FACILITY COMPLIANCE INSPECTION REPORT
Division of Waste Management
Solid Waste Section

COUNTY: Edgecombe
PERMIT NO.: 3302T-MSW-TRANSFER
FILE TYPE: COMPLIANCE

FACILITY NAME AND ADDRESS:
Edgecombe Co. MSWLF Transfer
2797 Colonial Road
Tarboro, North Carolina 27886

PURPOSE OF SITE VISIT:
Partial Audit

Aerial of the facility. Location of the grate, drain pipe, and ditch.

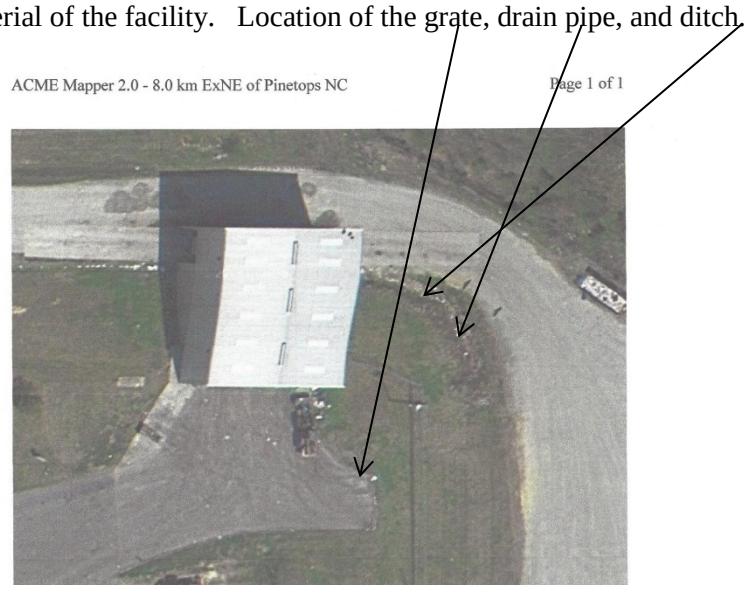
4. The drainage way along the base of the structure has been cleaned of waste but needs to be piped or configured in some way to prevent waste from accumulating.
5. The grate that drains the turn ramp collects trash and other material. This drain conveys runoff into the ditch in the above photos. Any trash that flows through the grate ends up in this ditch. **A method needs to devised to prevent clogging of the grate from the accumulation of trash.**
